**Mark Disosway, P.E.**

Re: Amira Builders / Zasciurinkas Res. / Parcel ID: R10006-238 Columbia County, FL

This letter is in reference to inspection issues on the above referenced project.

a.

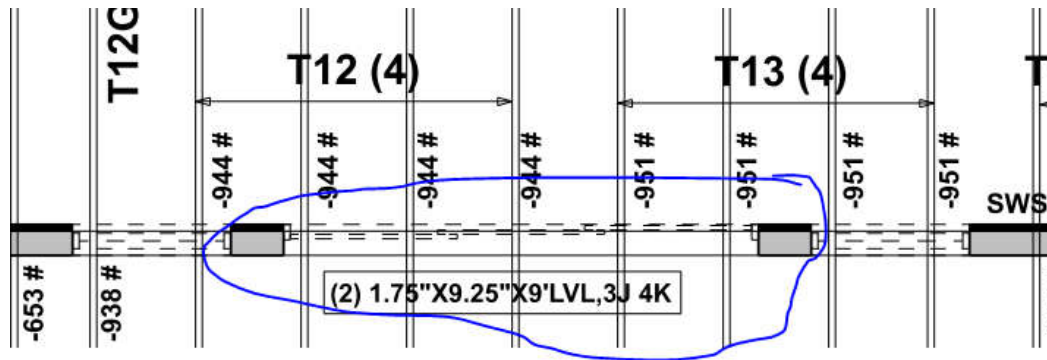
1. At the rear wall of the house the framer did not have enough room to put in all the jacks and king studs we call for. Below are the fixes.

At this location run the header continuous over the two side windows with (3) kings & (2) Jacks each end & (2) jacks mid points. Also box out the header with (2) 2x6 (1) top & (1) bottom of header. Also add HTT4 hold down bottom each end & (2) MSTA24 top each end.

At this location it is ok to use (4) kings & (2) Jacks each end. Also add HTT4 hold down bottom each end & (2) MSTA24 top each end.
